REPUBLIC OF THE PHILIPPINES  
DEPARTMENT OF BUDGET AND MANAGEMENT  
GENERAL SOLANO STREET, SAN MIGUEL, MANILA

**SUPPLEMENTAL/ BID BULLETIN (SBB) NO. 2**

This SBB No. 2 dated December 21, 2017 for the Project, "Renovation of the DBM Arcache Building," is issued to clarify, modify or amend items in the Bidding Documents. Accordingly, this shall form an integral part of said Documents.

BB2  
02  
26  
P-03

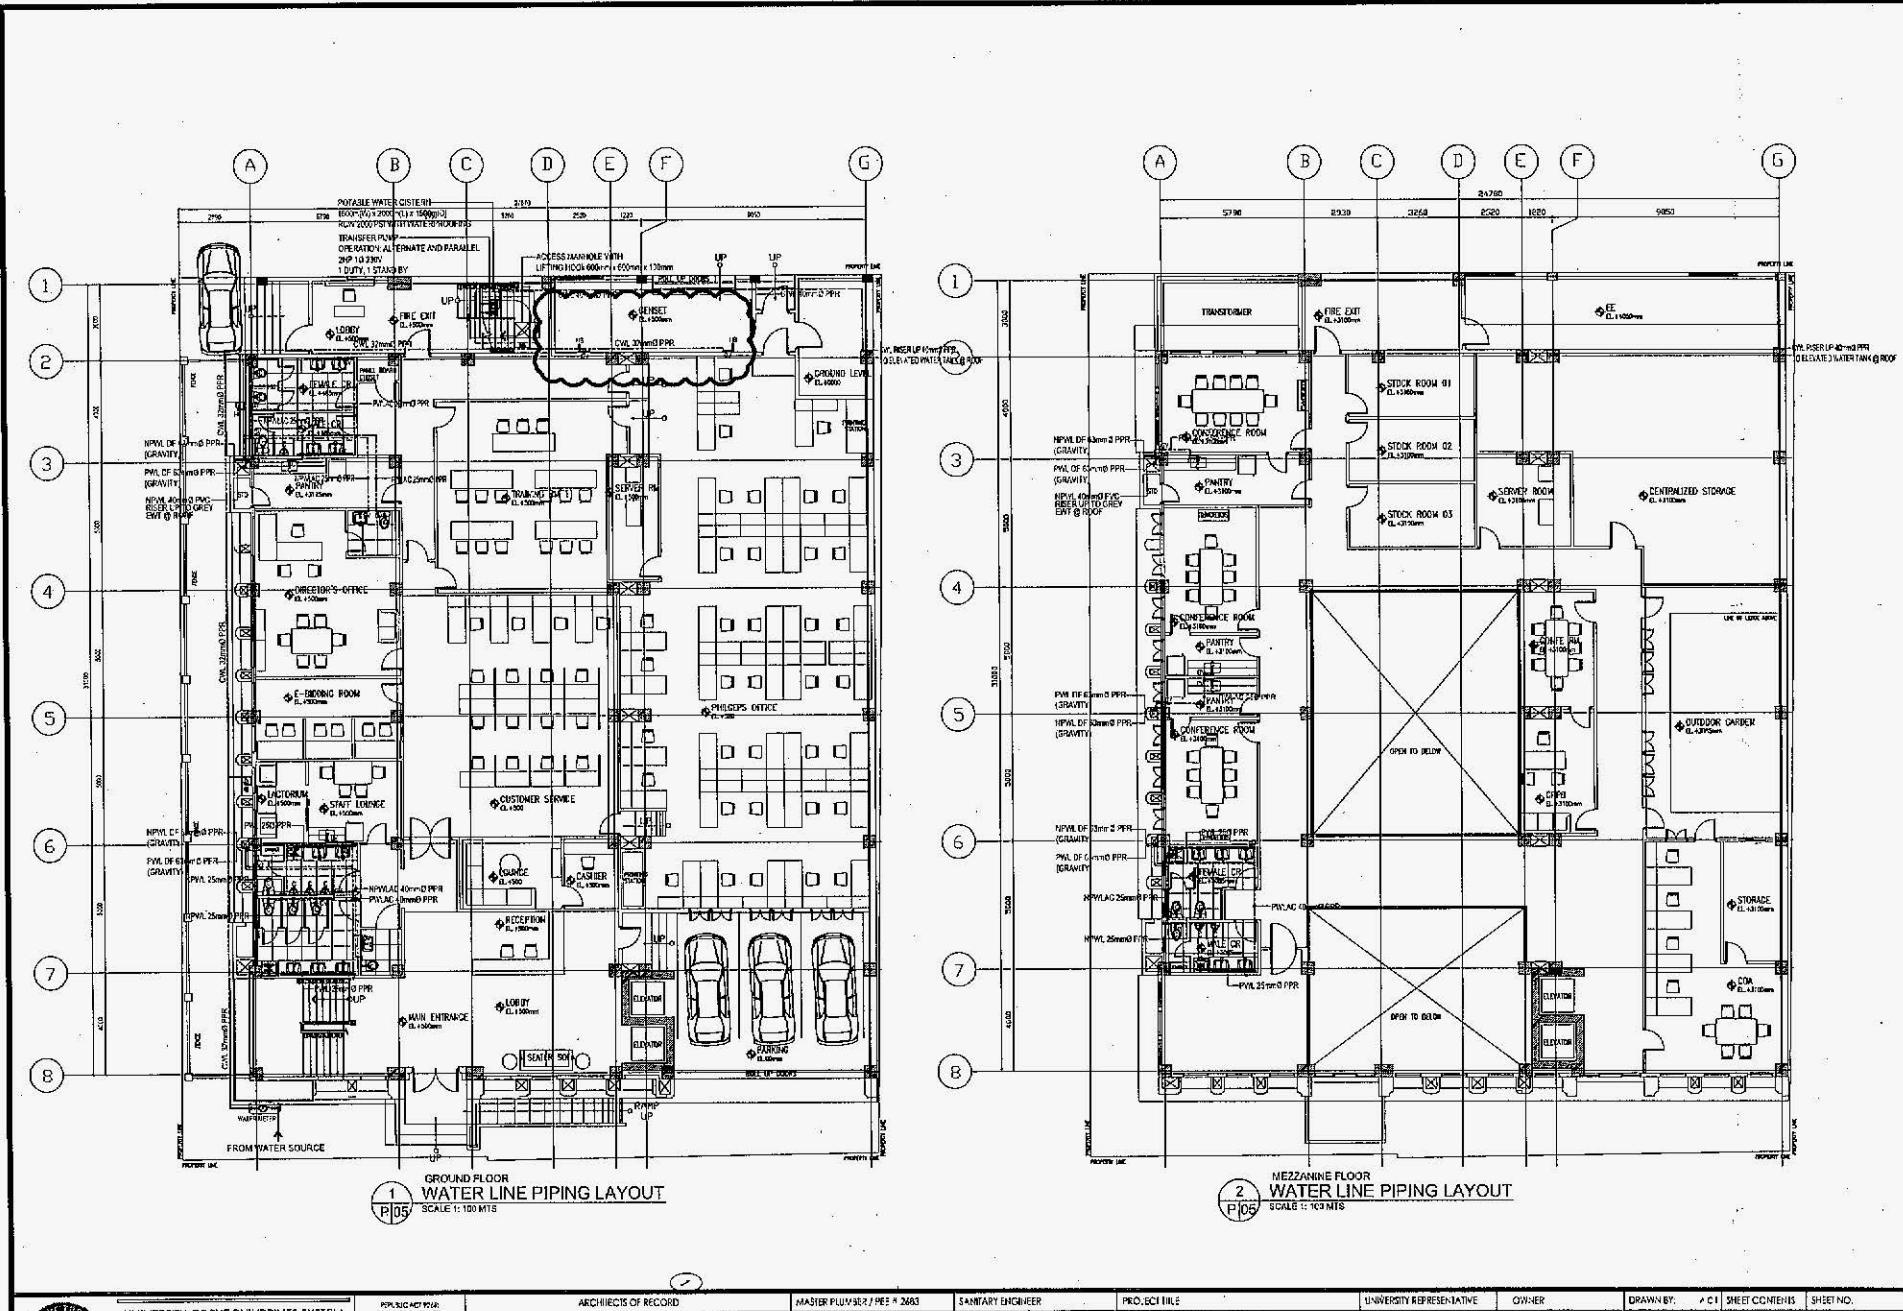
SHEET NO.	REVISIONS	BID BUL NO.
P-01	Septic tank details	BB2-01
P-03	STP tank resized	BB2-02
P-05	Additional hose bib at Generator room	BB2-03
P-07	Additional transfer pump at Roof deck for Elevated Grey water tank	BB2-04
P-18	Riser diagram for non-potable water line	BB2-05
M-02		BB2-06
M-03	Revise equipment schedule for wall exhaust fan	BB2-07
M-04	Re- route of ducting and refrigerant pipes	BB2-08
M-05		BB2-09
M-06	Additional exhaust fan on plan	BB2-10
FP-01		BB2-11
FP-02	Reroute of sprinkler pipes and additional wet stand pipe	BB2-12
FP-03		BB2-13
FP-04		BB2-14
FP-05	Detail of fire pump	BB2-14A
E-01	Revised electrical riser diagram - see notes on plan	BB2-15
E-02	Revised load schedule	BB2-16
E-03	Revised load schedule	BB2-17
E-04	Revised load schedule	BB2-18
E-05	Revised load schedule	BB2-19
E-06	Additional outlet provisions	BB2-20
E-07	Additional outlet provisions	BB2-21
E-10		BB2-22
AUX-01	Additional CCTV's at riser diagram	BB2-24

BB2  
 23  
 26  
 E-11

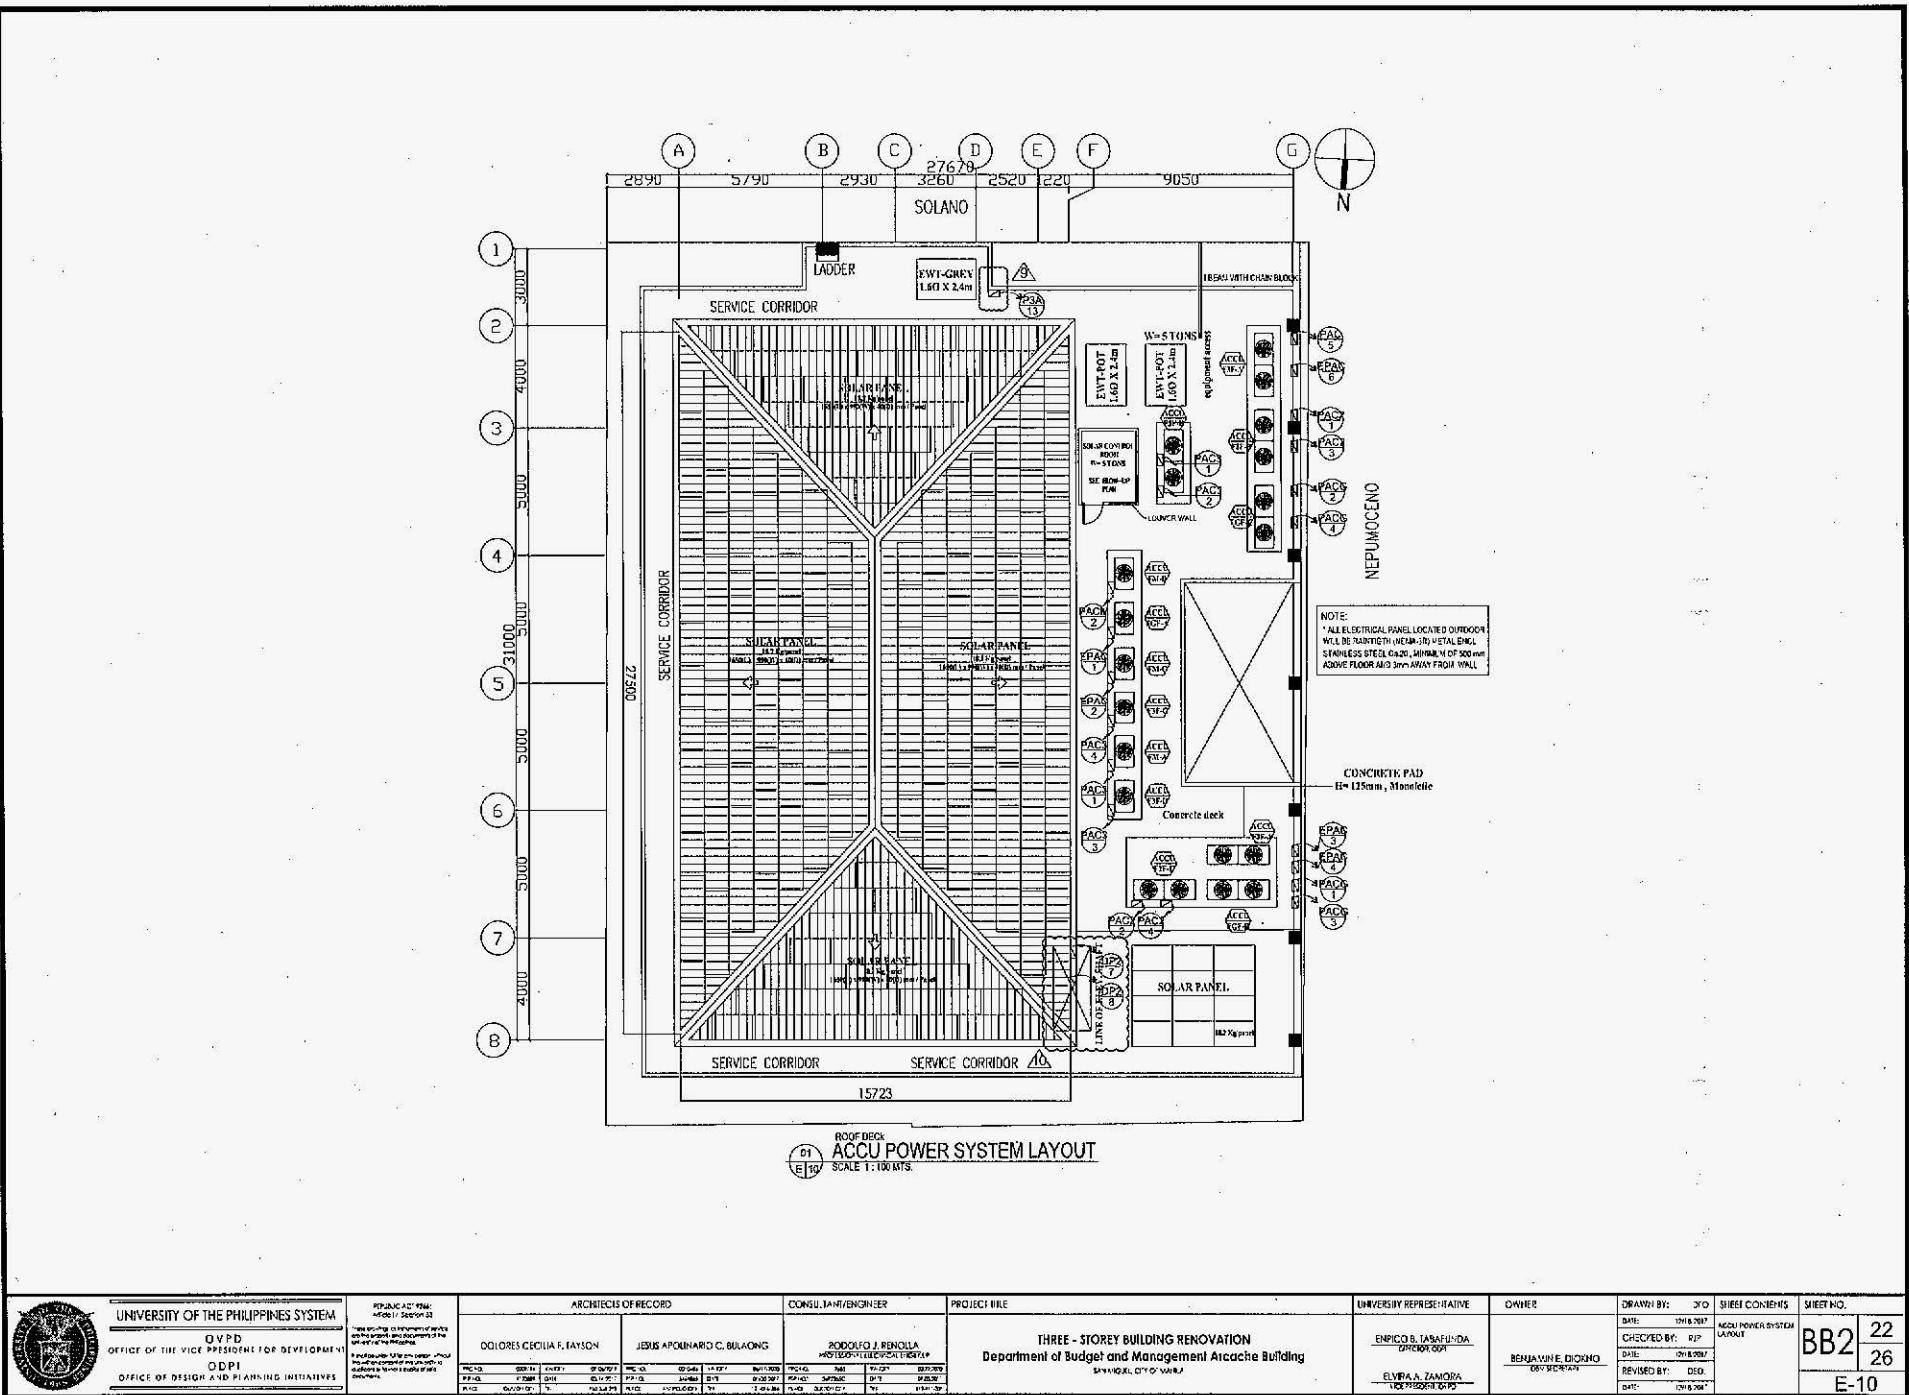
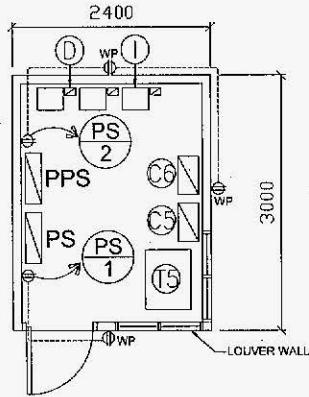
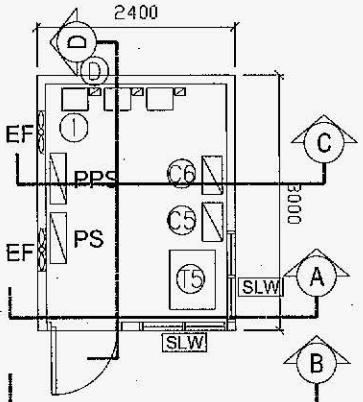
SHEET NO.	REVISIONS	BID BUL NO.
E-11	Additional details for Solar Panel	BB2-23
